AGENDA REPORT

Date: January 22, 2013
To: City Council
Thru: Ted Barkley, City Manager 
From: Mike Smith, Community Development Director 
RE: Special Meeting with the Planning Commission
• Land Development Code Update Project

TOP DISCUSSION ITEMS
JANUARY 28, 2013
JOINT SPECIAL MEETING
CITY COUNCIL and PLANNING COMMISSION

**Planning Commission Comments
Land Development Code**

15.56.070(D) – Wall signs, Maximum size, building or center name

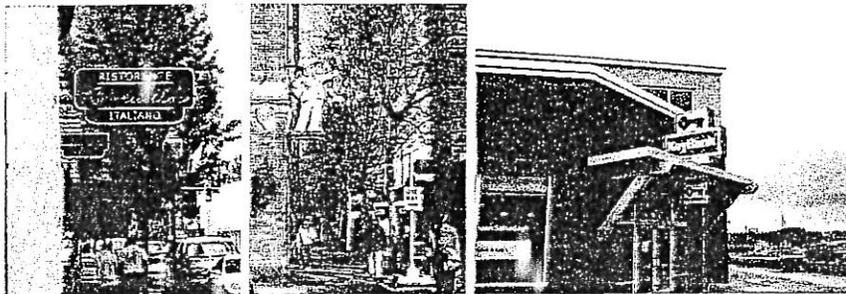
Sections C, D and E are confusing. There was a discussion on whether the size of the signs allowed in sections D and E are out of scale for Ellensburg. There was public comment suggesting to eliminate the language in "D" allowing "1 square foot for each lineal foot of the façade" and just rely on the maximum wall sign up to 100 square foot. There was not unanimous agreement on this issue. The most critical standards here that impact sign size – besides the area (sf) standards, are (A)(1) – signs must be centered and proportional...and (2) must not cover windows or special ornamentation, and (C)(2) signs shall not exceed 2/3 of overall storefront dimensions. The standards that are proposed have evolved over years of working on the issue with other communities, looking at what provisions work well, what's too restrictive, and what's the minimum requirement.

Motion:

Amend this section to read:

"A wall sign may be 1 square foot for each lineal foot of the façade, up to a maximum of 100 square feet."
